SAMRA Planning Observation Report

Third Party Planning Observation Report in respect of An Bord Pleanála planning application, reg. ref. PA29N.320250, which pertains to the proposed '3FM Project' consisting a Southern Port Access Route and road network improvements, construction of a Lo-Lo container terminal, Ro-Ro freight terminal and other works at Bond Drive, Promenade Road, T10 Link Road, Tolka Quay Road, Alexandra Road, East Wall Road, North Wall Quay Extension (protected structure), Oil Berth No. 4 and Berth 52/53 in Dublin 1 and 3; east of Tom Clarke Bridge, north of the R131 and over the River Liffey; Pigeon House Road, South Bank Road, Whitebank Road and Shellybanks Road; Poolbeg Yacht & Boat Club, Stella Maris Rowing Club and Marina off Pigeon House Road; Marine Terminals Limited (MTL) Lift-on Lift-off (Lo-Lo) container terminal and Berths 41-45 off Pigeon House Road, South Bank Road and Whitebank Road; quayside yards associated with South Bank Quay off Pigeon House Road; sludge jetty and Berth 47A off Pigeon House Road; Poolbeg Oil Jetty and Berth 48 off Pigeon House Road; and; a site to the south and east of South Bank Road and south of Shellybanks Road at Poolbeg, Dub

Fig. 10: Excerpt from the applicant cross section drawings showing the true height of the proposed boundary treatment (Source: Dwg. No. CP1901-3FM-RPS-S45-07-DR-C-0704)

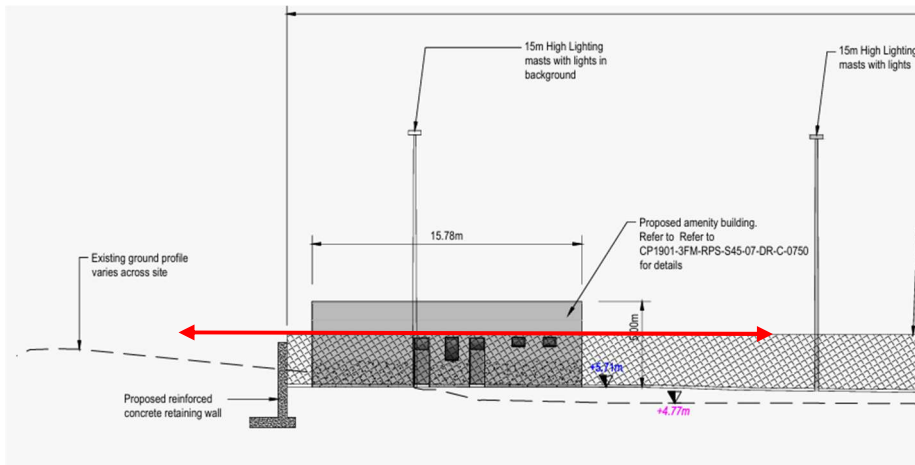
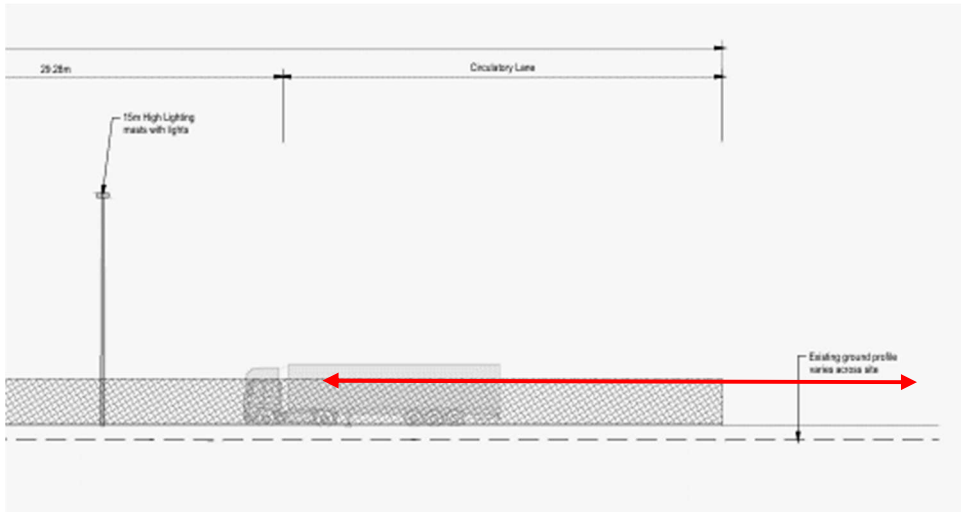
2. No cross section of the Ro-Ro Terminal Yard is provided which correctly shows the entirety of the proposed southern boundary treatment which rises to 5.5m tall. Dwg. No. CP1901-3FM-RPS-S45-07-DR-C-0709 is an elevation drawing and not a cross section. A cross section would show the true height of the wall/fence combination.

4. The south elevations of the Ro-Ro Terminal Yard shown in Dwg. No. CP1901-3FM-RPS-S45-07-DR-C-0709 are incorrect (indeed all the elevations are incorrect). They do not show the retaining wall on which the fence is sited. The drawing is wholly incorrect, misleading, and does not correspond to the other applicant drawings (see Figs. 9 to 14). The wall/fence combination rises to 5.5m tall and this would screen the applicant block and all trucks within the Ro-Ro Terminal Yard. The applicant drawings need to be amended to show the true scale of the fence as it would be viewed from areas represented by SAMRA. For example, to any person walking the adjoining public amenity path to the south, this boundary treatment would appear as massive and prison-like, while it would be visible from the wider area in all views (until such a time as any screening trees grow to heights over 5.5m tall). To SAMRA, there appears to be no reason why the cumulative of the wall and fence height needs to be so tall.

Fig. 15: Excerpt from Page 4 of the submitted 'Active Travel: Architectural Design Report' (Source: Applicant 'Active Travel: Architectural Design Report')

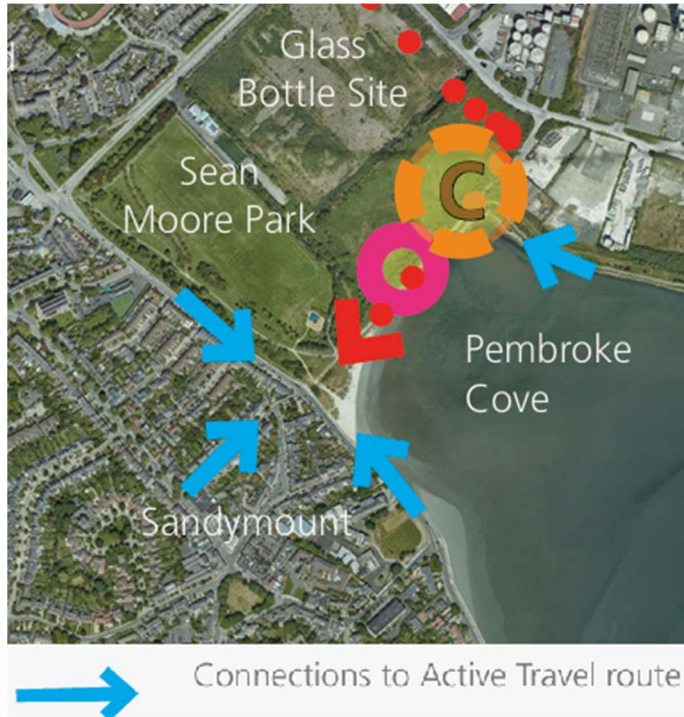
6. Page 5 of the 'Active Travel: Architectural Design Report' is misleading and inaccurate. The applicant shows 'Connections to the Active Travel route' which are outside of the submitted red line site boundary. All areas south of the red arrow in Fig. 15 are excluded from the project and essentially comprise sand paths unsuitable for cyclists of any kind. There is no existing safe way for cyclists to pass from the road and north towards the applicant's 'Active Travel route'. Cyclists must get off their bikes and wheel them to achieve this manoeuvre, to find the path cannot accommodate them. Existing cyclists do not use this path and none with use it without improvements.

Fig. 16: Excerpt from Page 5 of the submitted 'Active Travel: Architectural Design Report' (Source: Applicant 'Active Travel: Architectural Design Report')

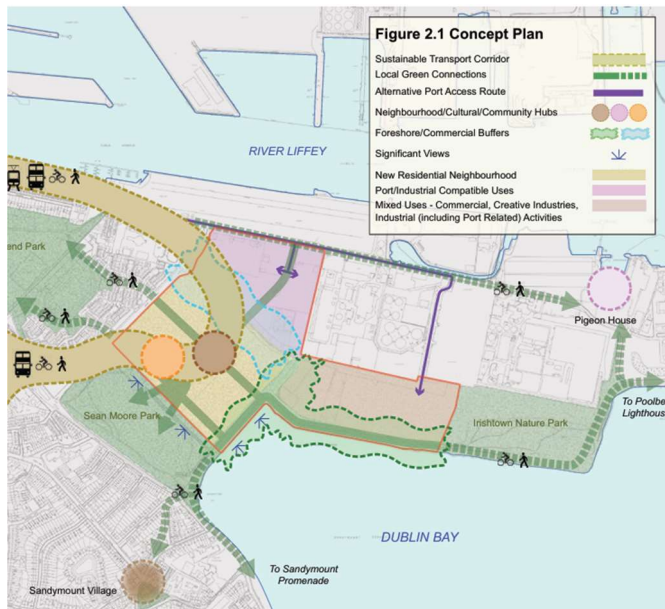
7. Page 5 and Fig. 2.1 of the submitted 'Active Travel: Architectural Design Report' are misleading as they show cyclists passing into and out of the existing path from the Beach Road. This path is unsuitable for cyclists in its present design and finishes – it is also unlit. There is no "Green Connection" to Sandymount Village and promenade for cyclists (as shown in Fig. 16 of this report). Cyclists use the roads for commuting in the absence of segregated and accessible cycle lanes at this location.

Fig. 20: "Significant Views" as set out in the Poolbeg West SDZ Planning Scheme (Source: Fig. 2.1 of the Poolbeg West SDZ Planning Scheme)

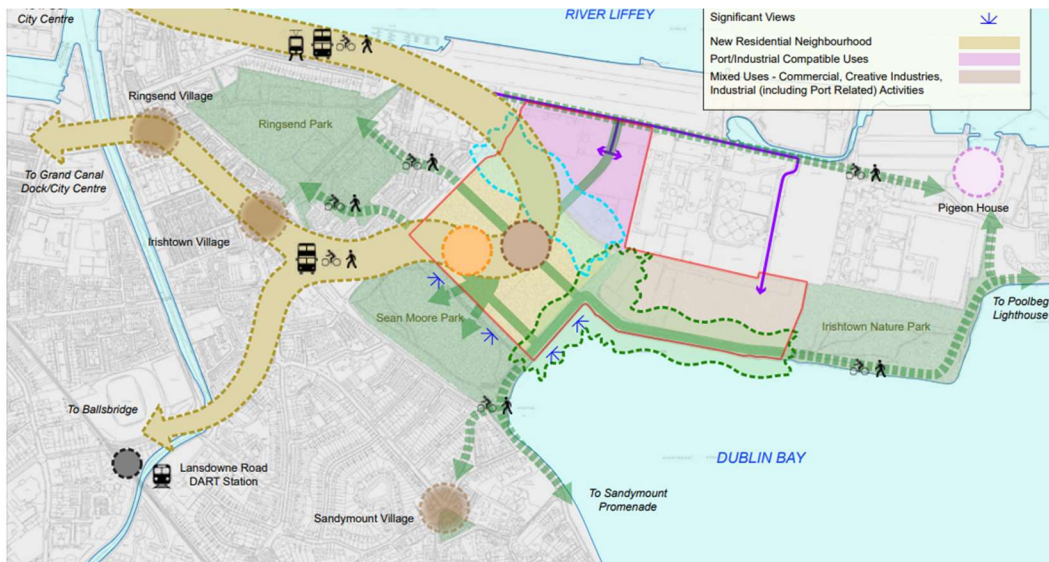
Fig. 2.1 "Significant Views" as set out in the Poolbeg West SDZ Planning Scheme shows how the Ro-Ro Terminal Yard would be visible within what is a view recognised by a statutory plan. The Planning Scheme document refers to how: "To the south lies the sweep of Sandymount Strand." Section 10.2 'Ambition & Aims' seeks: "To exploit the area's outstanding natural amenity and topography by opening views to the sea, coast, mountains and nature reserves, having regard to solar orientation and environmental comfort."

Fig. 58: Search result from Dublin City Council's Active Travel Network's GIS mapping (Source: Web based source⁹)

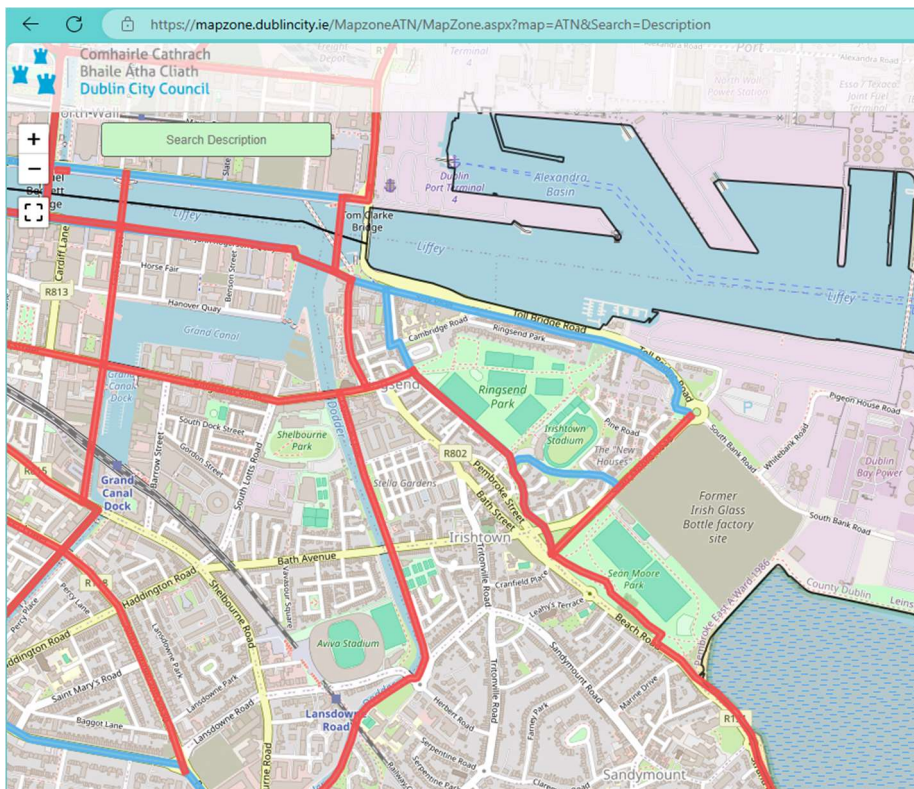
It is unclear if the cycle lanes and/or notional shared pedestrian/cycle facilities are intended to be part of the long planned Sutton to Sandycove cycle route, what the NTA's Cycle Network Plan calls the 'East Coast Trail', or what Dublin City Council now refers to as the Active Travel Network (see Fig. 58).

Fig. 84: Excerpt from the applicant drawings showing an Active Travel Path – shared pedestrian/cycle lane – passing to and from Sandymount and Merrion areas (Source: Dwg. No. CP1901_3FM-RPS_S26-HGN-XX-DR-HE-100-0006)

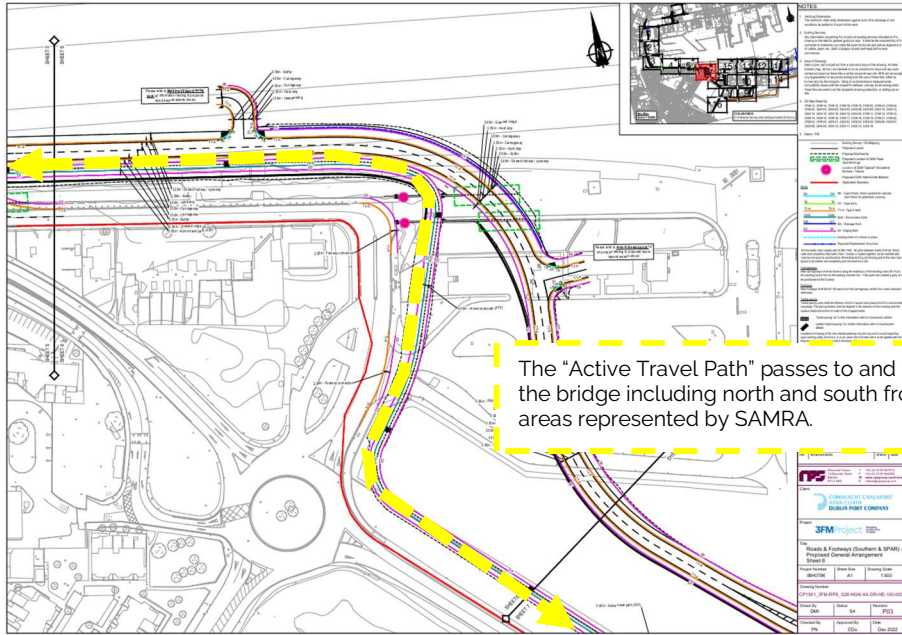
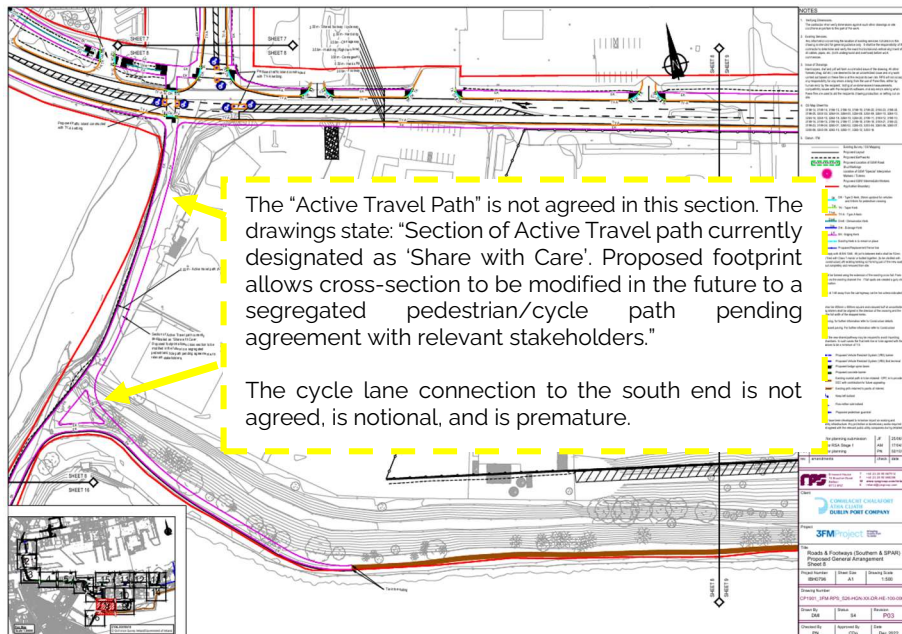
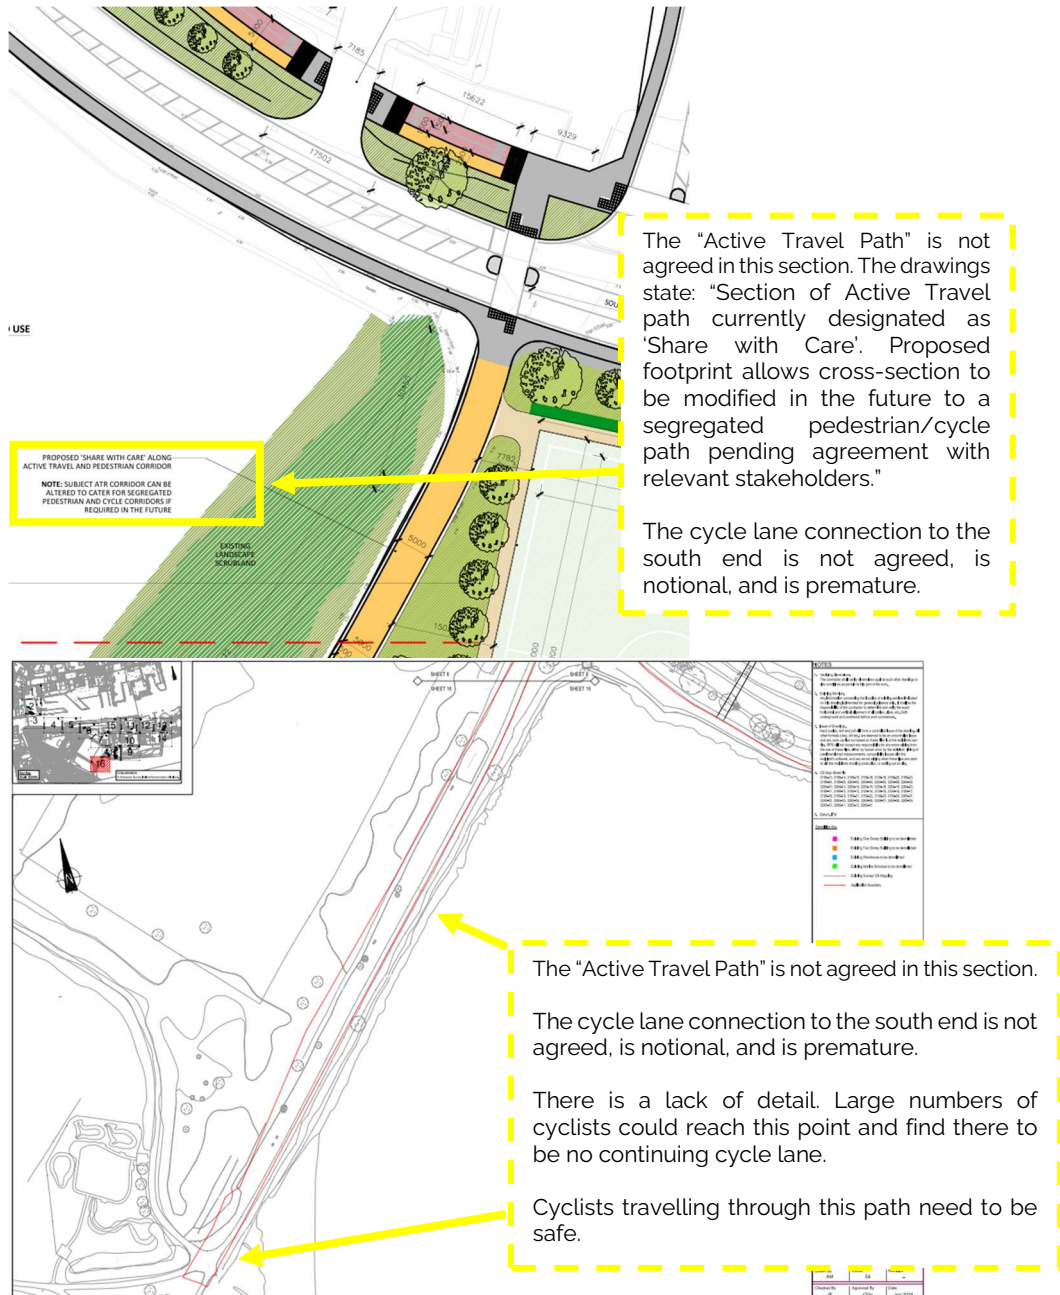
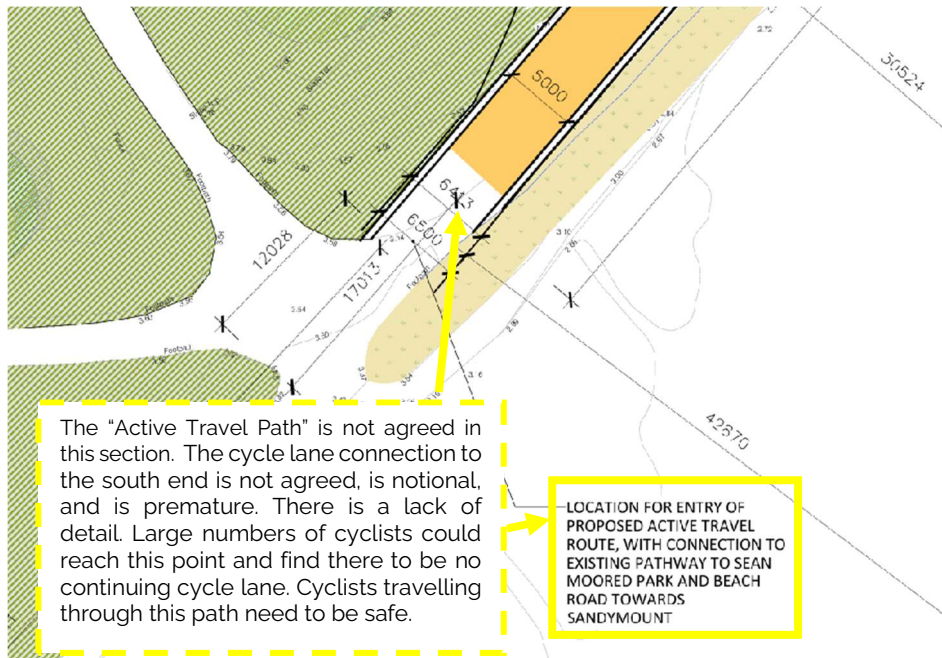
Regarding the specific proposals, Figs. 84 to 87 show an Active Travel Path passing from the SPAR towards an existing part-gravelled and part-tarmac surfaced footpath which passes along Sandymount Strand to the R802. This part of the cycle path proposals is, as set out below, poorly developed and incomplete. This section appears not to have been agreed with DCC despite having a notional design included in the planning application, while another section has no notional design but is included in the red line boundary.

Fig. 88: Excerpt from the applicant drawings showing the possible future upgrading of the existing footpath from the site to Beach Road and along Sandymount Strand to provide for cyclists (Source: Dwg. No. CP1901_3FM-RPS_S26-PGN-XX-DR-HE-100-0011)

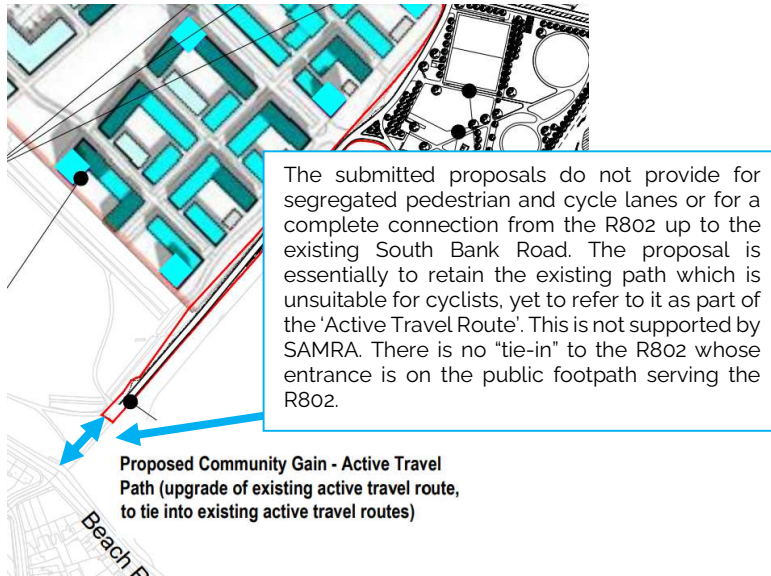
Fig. 88 shows the applicant's notional proposal to apparently "upgrade" only **part** of the existing path which passes from the site to Beach Road along Sandymount Strand. As Figs. 88 to 101 show, the applicant proposals stop well short of Beach Road and do not address the wholly unsatisfactory interface of the path for cyclists who wish to access it from Beach Road. Chapter 14 'Traffic & Transportation' of the EIA is misleading when it states that "Active Travel connections" will connect to the wider Sandymount area as cyclists could not get from the south end of the (much stated throughout the documentation) Active Travel Path to the Beach Road. One would need to get on and off a bike to achieve the manoeuvre.

Fig. 89: Excerpt from Roads & Footways (Southern & SPAR) - Proposed General Arrangement Sheet 8 (Source: Dwg. No. CP1901_3FM-RPS_S26-HGN-XX-DR-HE-100-0008)

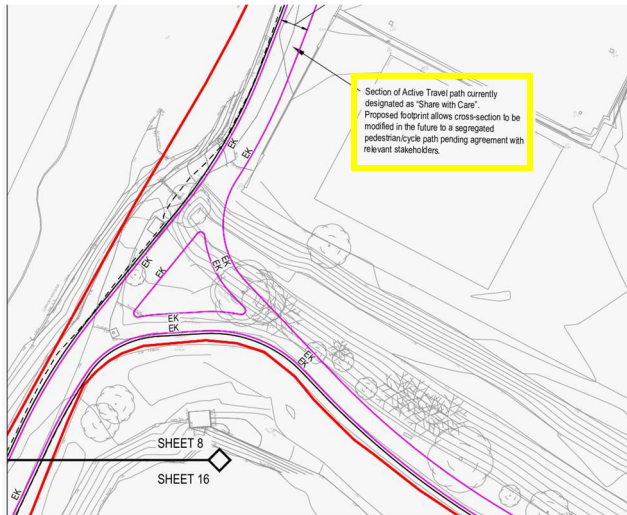
However, the applicant's drawings (see, for example, Fig. 89) currently state: "PROPOSED 'SHARE WITH CARE' ALONG ACTIVE TRAVEL AND PEDESTRIAN CORRIDOR NOTE: SUBJECT ATR CORRIDOR CAN BE ALTERED TO CATER FOR SEGREGATED PEDESTRIAN AND CYCLE CORRIDORS IF REQUIRED IN THE FUTURE" and "Section of Active Travel path currently designated as 'Share with Care'. Proposed footprint allows cross-section to be modified in the future to a segregated pedestrian/cycle path pending agreement with relevant stakeholders." The applicant does not appear to have reached any consensus as to the use of these paths for pedestrians **and** cyclists. The proposals appear notional and premature.

Fig. 102: Excerpt from Roads & Footways (Southern & SPAR) - Proposed General Arrangement Sheet 8 (Source: Dwg. No. CP1901_3FM-RPS_S26-HGN-XX-DR-HE-100-0008)

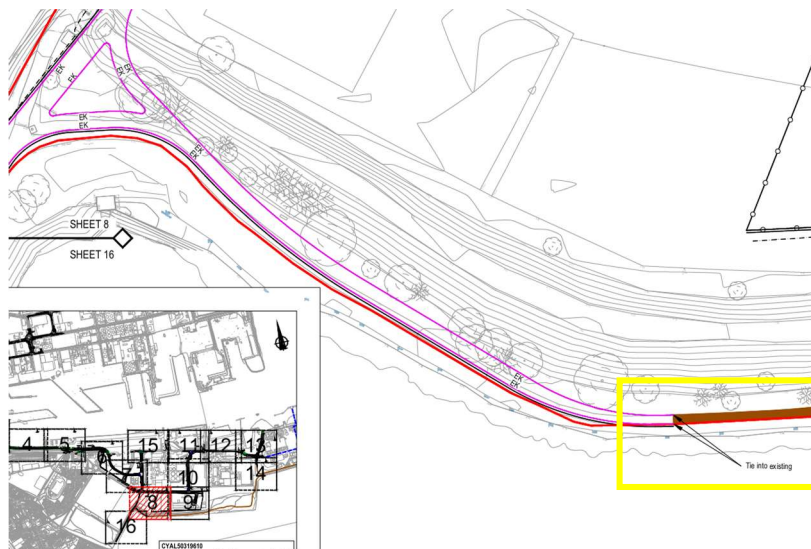
Further, as Fig. 102 illustrates, the applicant drawing state: “Tie into existing”. This means that cyclists could reach an abrupt end to the shared cycle lane and at a point where the path thins (see Fig. 103). The proposed up to 3,566m wide (preferably 6m wide) pedestrian/cycle path would meet the existing thin path at a bottle neck. This is poorly considered and likely dangerous. A Road Safety Audit of the proposals would likely identify this.

Fig. 11.1: Figure 11.2 'Movement Proposals and Land Use' of the SDZ's Planning Scheme (Source: Online reference¹⁵)

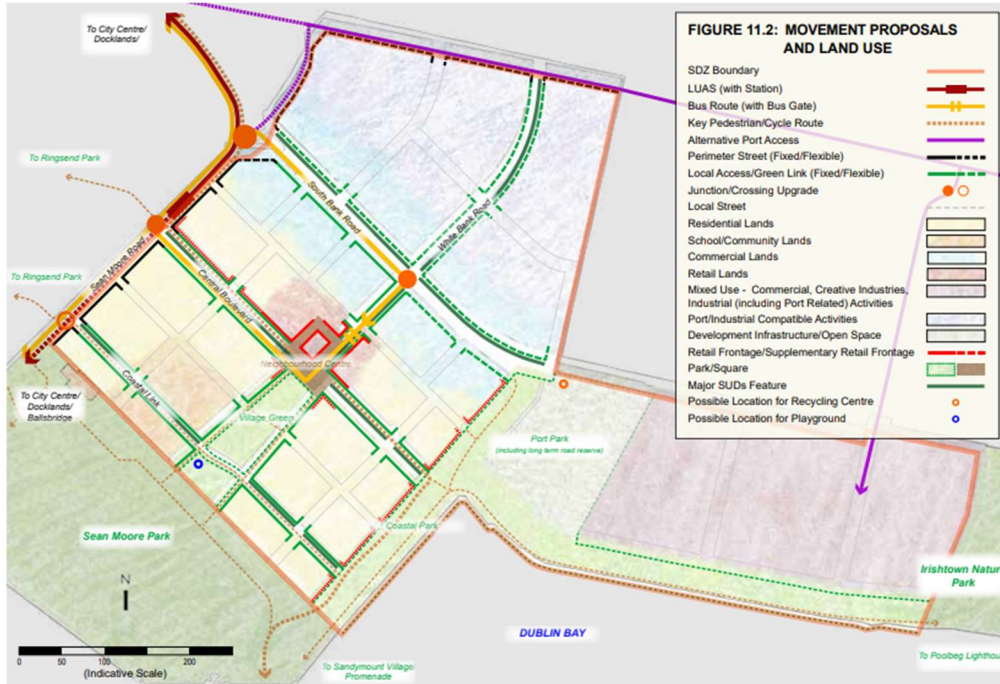
Figure 11.2 'Movement Proposals and Land Use' of the SDZ's Planning Scheme show:

- A 'Local Access/Green Link (Fixed/Flexible)' passing along the boundary of lands zoned Mixed use (which are included by the applicant as a Ro-Ro Terminal Yard) 'and' a 'Key Pedestrian/Cycle Route'. That is, there are two paths and not one as shown by the 3FM proposals. These paths pass along the boundary of the Ro-Ro-Yard 'and' along the edge of the coast. These two paths may allow cycling and walking to take place safely.
- Similarly, two 'Key Pedestrian/Cycle Routes' are shown passing from Beach Road to South Bank Road (See also Figure A2.22. 'Green Link from Dublin city centre towards Poolbeg Lighthouse cross the Coastal Park').
- Finally, 'Local Access/Green Link (Fixed/Flexible)' is applied to South Bank Road as it passes towards the existing toll bridge.
